TECHNICAL NOTE TN-1038b-SR

TM8100 Firmware v2.09 and Programming Application v2.92

25 July 2005

This Software Release Note applies to the TM8100 Mobile Radios.

Power-up Changes

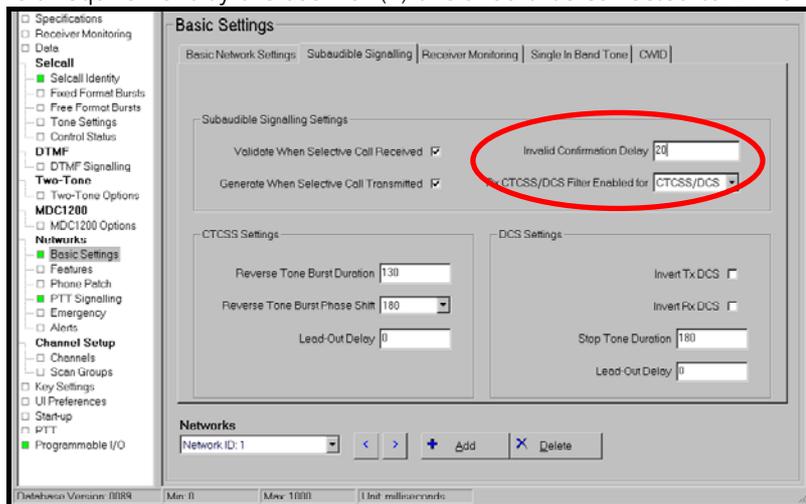
- The Programmable I/O option Toggle Standby Mode has been renamed Power ON (Stand-by).
- The Programmable I/O option Power Sense (Ignition) can only be assigned to AUX_GPI3 and can only be active HIGH. Although the Programming App allowed it, the Hardware was not designed to work with this line as active Low.
- When Action Enter Emergency Mode is selected for AUX_GPI2, then the line can only be active LOW. This option can only be assigned to either AUX_GPI2 or IOP_GPIO7.
- A new Programmable I/O option has been created called Power Sense (Internal); this Input action can only be assigned to IOP_GPIO7 and can only be set as active HIGH.

Selcall's that don't work?

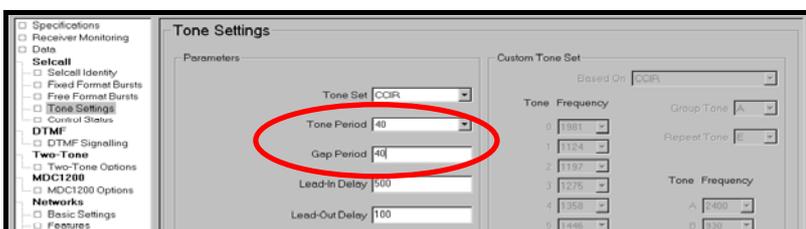
The **Selcall > Tone Settings** page allows the Selcall system user to define the Tone Period and also the Gap Period. The values of these fields are both defaulted to 20ms, but can be variable from the drop-down box on the Tone Period and between 10 and 150 ms in the Gap Period.

The most common reason for a radio that won't decode a Selcall is the Gap Period has been set to a lower value in comparison to the Tone Period. The solution is to set the Gap Period **exactly** the same as the Tone Period, even if the defined sequences do not use Gaps. The Selcall decoder will identify the space between individual Tones as valid Gaps and interpret the incoming format as such. Technically the Gap should be at least 66% duration of the defined Tone Period.

**TMAA02-08
Keypad
Microphone**

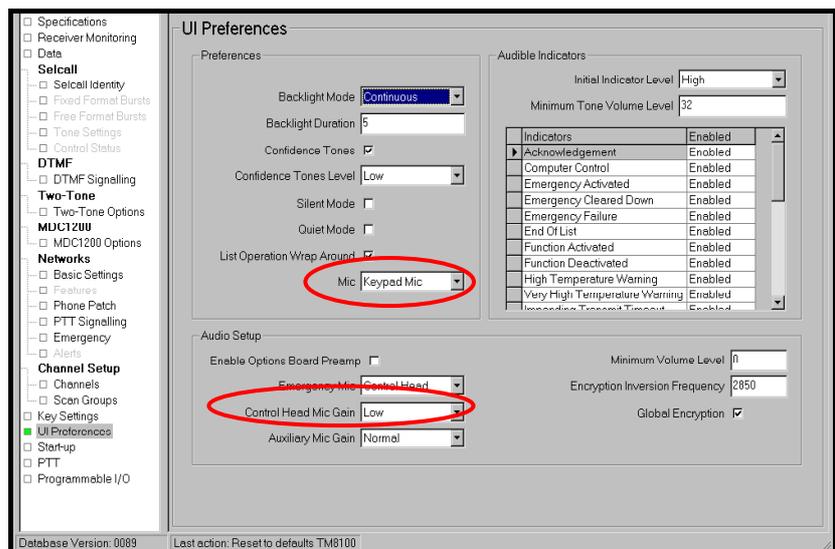
As shown in the screenshot below, the new field Mic on the UI Preferences page allows the option of Keypad Mic. When this is enabled the radio will expect there to be a TMAA02-08 Keypad Mic to be connected and allow direct entry to any 2-digit channel/group ID.

- The audio gain of the TMAA02-08 is slightly higher than the TMAA02-01 standard microphone and if this causes issues for customer's it is suggested the Control Head Mic Gain be set to Low.

- The Control head port cannot be enabled for keypad Mic if the Data Port or the GPS Port is already set to Mic.
- Once the radio is programmed for the TMAA02-08 it will need to be powered-off and on when reading and writing in the same fashion as transparent data as the port is only expecting data from the Mic.

- When entering channel ID's two digits are always required i.e.: Channel 8 is entered as '08'. The user has 3 seconds after the first digit to enter the second digit. If this time expires OR the requested ID does not exist the radio will revert to the previous channel ID.

Transmitter Lead-Out Delay

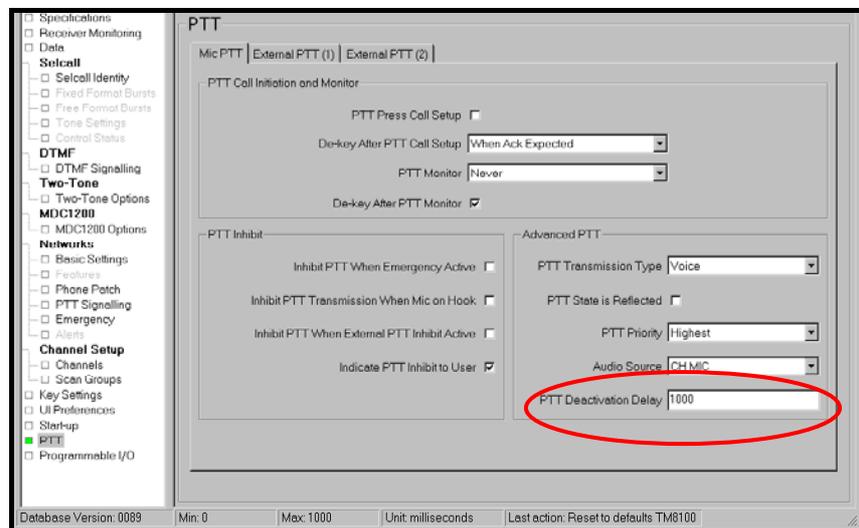
A new field has been introduced in the Programming Application providing a transmit 'hold' timer. The PTT Deactivation Delay can be set differently on each PTT tab from 0ms to 1000ms. Default is 0ms.

This duration will hold the radio in its previous transmitting state, complete with any signalling such as CTCSS, active. When the timer has elapsed the radio will process the normal PTT release functions such as Reverse Tone Burst, Trailing ANI etc if enabled.

- (1) An issue noted for a TCL customer where the radio was chopping off the last part of external input audio data due to the time required processing the data through the radio to air. In this case only a few milliseconds is required. Raised as Focus 18719.
- (2) Users who were coupling two TM8100's together as a repeater requested a way of encoding a transmitter 'repeater tail'. This could be achieved previously by paralleling two EPTT inputs and using different debounce settings for fast-attack and slow-release. But the maximum duration available was only 200ms.

TaitAx Scanning

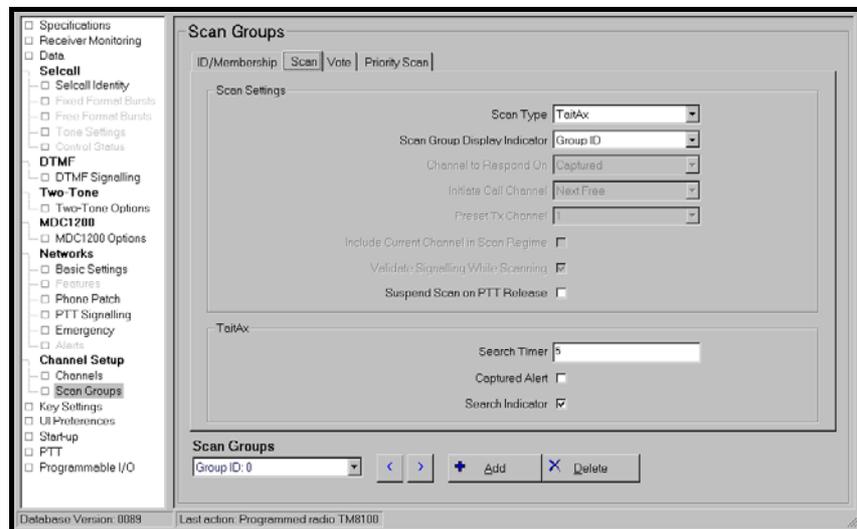
TaitAx (also known as MultiAx) is a Scan group type that operates the same as a Standard scan type until the PTT is pressed or 'flashed', then the radio starts looking for the **next free** channel that it can transmit on.

If the scan group has become idle OR the Group Hold Timer has expired and a user PTT's, the radio will select the **next** channel in the scan list and transmit on that.

The radio will always transmit on any currently captured channel (until the Group Hold Timer expires) as per Standard Scan operation.

If no channel is free and the Search Timer duration (variable between 1 and 10 seconds) has elapsed, the Tx inhibit tone [a single low-tone beep] sounds, and scanning resumes.

Captured Alert, when selected will give the Channel Freed tone [a triple-beep sequence] when a valid free channel is available.

Search Indicator, when selected will give the Search tone [a bop-bop sequence] when it is looking for a free channel.

MDC1200 Signalling

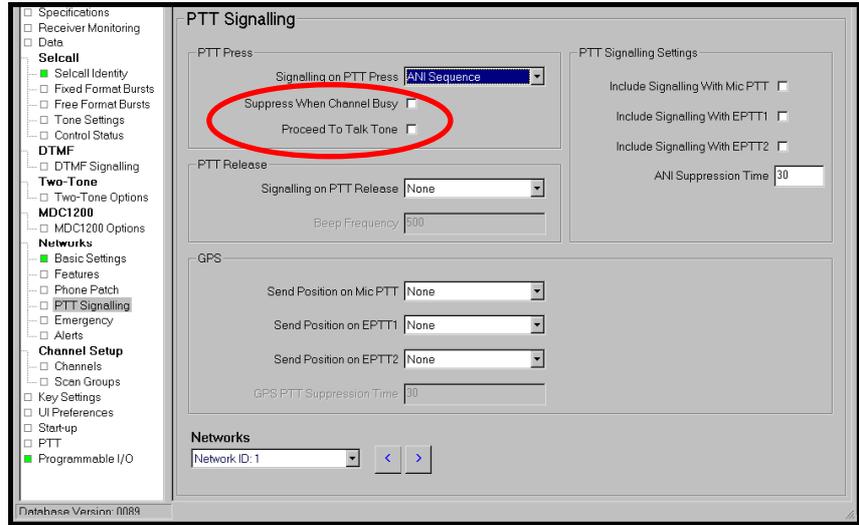
MDC1200 (encode only) Signalling is now supported within TM8100 firmware. Up to 4 different MDC1200 profiles can be defined.

The network can have a MDC1200 profile in the same way as a DTMF or Selcall profile.

The Radio ID uniquely identifies the radio when transmitting MDC1200 ANI or emergency sequences on channels associated with this channel profile. The ID is in 4-digit hexadecimal format (0 to 9 and A to F).

The ANI Sequence and Emergency Sequence can all be defined with different ID's if desired.

CWID

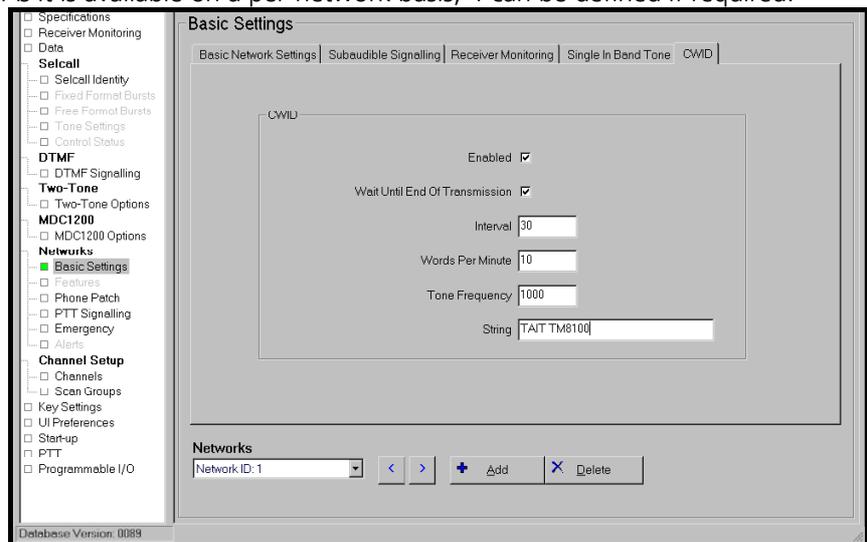
A new tab has been added to **Networks > Basic Settings** called CWID. CWID is Carrier Wave Identity. On FM systems tones are used to duplicate the effect of Carrier Wave being received. The Tone Frequency can be varied from 400 to 2000 Hz.

The Interval is the time between Strings being sent to air in 1-minute steps from 1 to 240. The message string is not sent over any active transmission if Wait Until End Of Transmission is enabled.

The String can consist of up to 30 elements from the list of: 0123456789ABCDEFGHIJKLMNQRSTUUVWXYZ.,:?'-/()". This includes spaces. The default text is "MESSAGE". The message is sent over the air at a Words Per Minute rate between 5 and 30 in 5wpm steps.

As it is available on a per-network basis, 4 can be defined if required.

Combine and Combine (0dB)

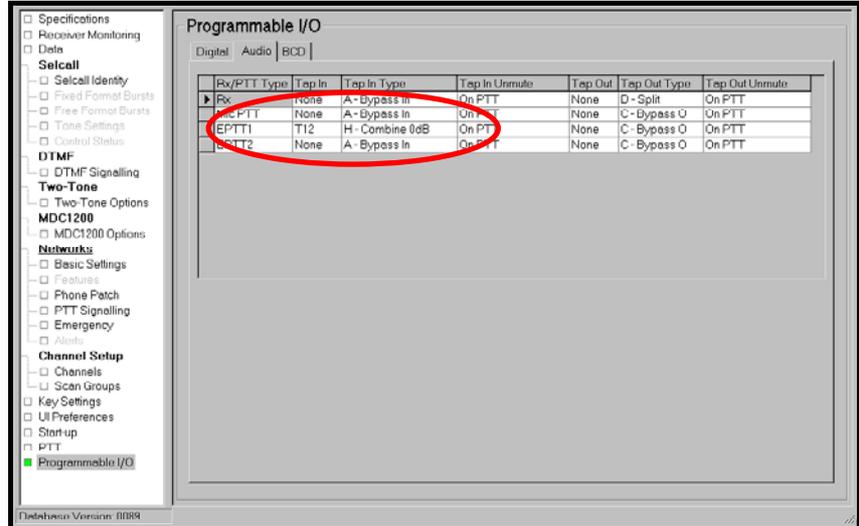
Originally developed for the TB7100 Base station, a new Tap_In type called H-Combine 0dB has been added to Programmable I/O > Audio tab in the Programming Application.

The TB7100 uses T12 Tap-In for MPT1327 trunking applications where FFSK from the CCM and normal speech audio are both required to be processed by the transmitter.

Speech audio is applied via Aux_Mic_Aud but it is not desirable to have this audio scaled by -6dB, using just B-Combine, as this will result in only half the required deviation and increasing the audio drive level to compensate, would cause the limiter to prevent this increase being passed on to tap T12.

1200 Baud FFSK in T2000-A75 systems

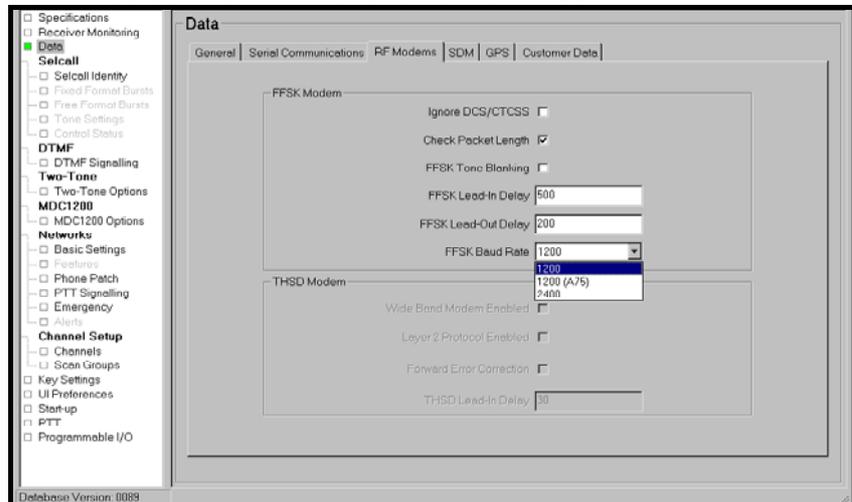
FFSK 1200 baud on the T2000-A75 (data interface board) runs approx 8bps slower than on the TM8100. Some customer's experienced problems putting new TM8100's into those existing networks.

The standard TM8100 implementation has a shorter first frame of 16 bytes to help get onto the channel quicker. For normal operation this has no effect on overall modem performance, however transmitted data with long strings of 'zeros' or 'ones' results in the first symbol transition following the long same-symbol string being lost altogether or replicated depending on the direction of data between the TM8100 and the T2000-A75.

The implemented solution in the TM8100 checks for long strings of 'zeros' or 'ones' and when the string length reaches 20, the symbol interval for the next transmitted symbol is increased by one sample.

Found in **Data > RF Modems**, the drop-down box for FFSK Baud Rate has the options of 1200 for normal TM8100 operation, 1200 (A75) for use with existing systems with T2000-A75's and 2400. This last option is to be included in later enhancement work on the TM8100.
